RE: 845 Juan Tabo NE
Grading and Drainage Plan
Hydrology File: K21D019

Based upon the information provided in your submittal received 09/27/2024, the Grading and Drainage plan is **not approved** for Building Permit / Grading Permit. The following comments need to be addressed for the approval of the above referenced project.

**845 JUAN TABO BLVD., NE
GRADING AND DRAINAGE PLAN**

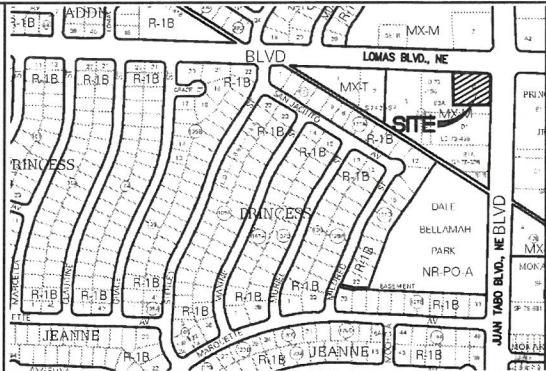
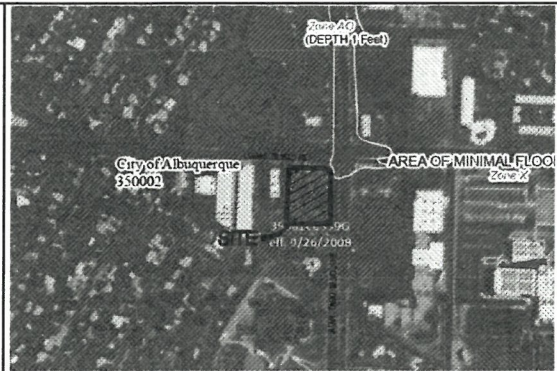
1. This site qualifies as redevelopment and is only required to retain runoff from the 80th percentile storm (Vol. = 0.26"*Imp.Area). To calculate the required SWQV, multiply the impervious area draining to the BMP by 0.26 inches for redevelopment sites.

2. Please show the Land Treatment (A, B, C, D) percentages for the existing and proposed development.
3. Please show the 100-yr 6-hr Weighted E, Volume, and Flow calculations for existing and Proposed development.

4. Please provide the SWQV calculations for each basin draining to each pond. The stormwater quality ponds need to be sized for the areas draining to them.

5. For trash enclosures serving food service developments, trash enclosures must demonstrate control of liquids from dumpster areas per DPM by containing runoff from the dumpster area, preventing outside drainage from entering the dumpster area, and discharging to the sanitary sewer. Per the DPM Section 6-12(D)(2), a berm around the pad may be required to ensure that stormwater runoff from the site will not mix with stormwater falling on the trash enclosure pad. Please show a berm or other means to prevent storm water from entering the dumpster area.

6. Pond Calculation Section – Pond C is not shown. Pond B is shown twice. The calculation is different for the middle Pond B Volume. 55000 cf for the middle Pond B does not match the other references. Total Pond Volume does not match the other calculated values. Please check these calculations and verify that they are matching the other volumes in the plan.

7. There is a conflict with Pond C and the existing transformer at the SE corner of the site. Please adjust Pond C to exclude the transformer from that area.
